# Important information about the Schilling KKP Master Data Update August 2023

## What has changed:

## Dachsystem Serie 3000

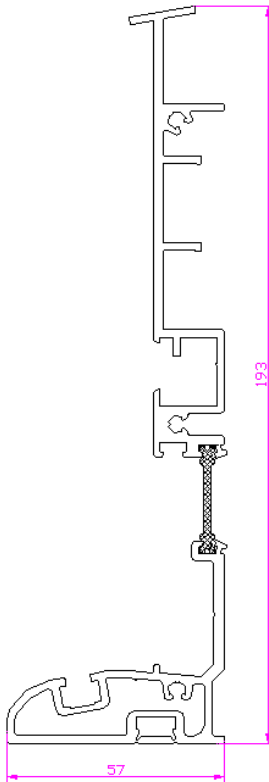
In the 3000 series, we have added an automatic exchange function for the glass cover in the wall rail, from glazing thickness 22 mm. Thus, it is no longer necessary to make manual adjustments in this area.

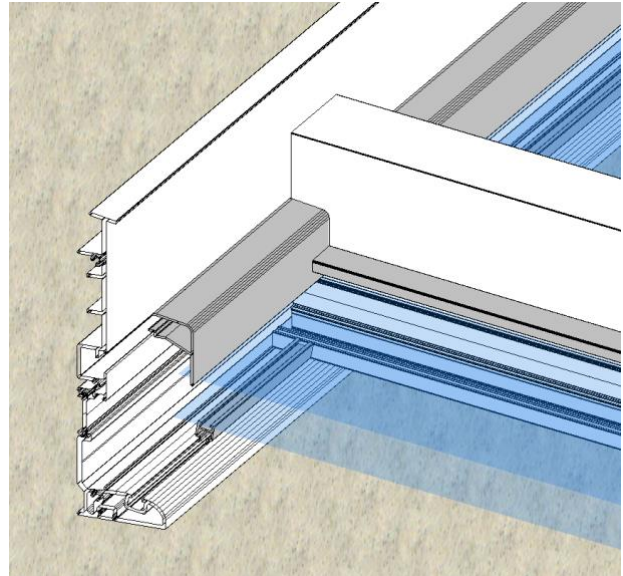
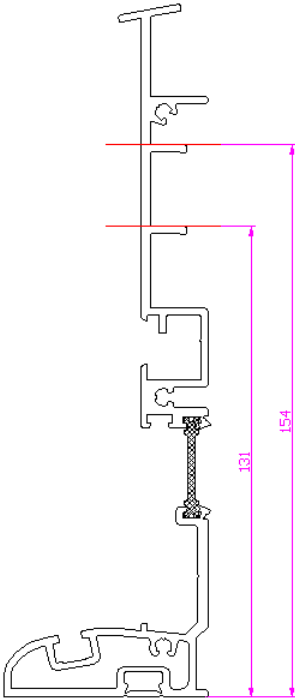
We are pleased to present our new wall rail in the 2100 series.

The 777806 wall rail will complement the previous 777805 wall rail, which has proven itself over a long period of time, in many areas of application.

- We would like to emphasize the following advantages:
- Greater overall height for rational accommodation of the 777830 center beam
- Roof pitch up to 18° across all system supports (higher roof pitches can be checked after consultation)
- Longer insulation bar for better thermal insulation
- The fastening area of the wall rail has been adapted to today's technical requirements
- The wall rail has been given a glazing bead receptacle so that the glass sealing is analogous to the one-piece wall rail 749805 of the 3000 series.
- With the standard glazing thickness of 28 mm, glazing bead 749807 can be used without additional processing.
- The end piece is mounted in screw channels provided for this purpose.

- In order to be able to use the advantages of the wall rail also for low mounting heights, the wall rail has two predefined dimensions for shortening the profile. The dimensions are matched to beams with an overall height of 125 mm and 85 mm. Professional sealing of the wall rail to the building structure is still possible without additional expense.

When inserting infill panels and glazing bead gasket combinations, it is important that the correct selection is made in advance. Subsequent replacement is not possible.
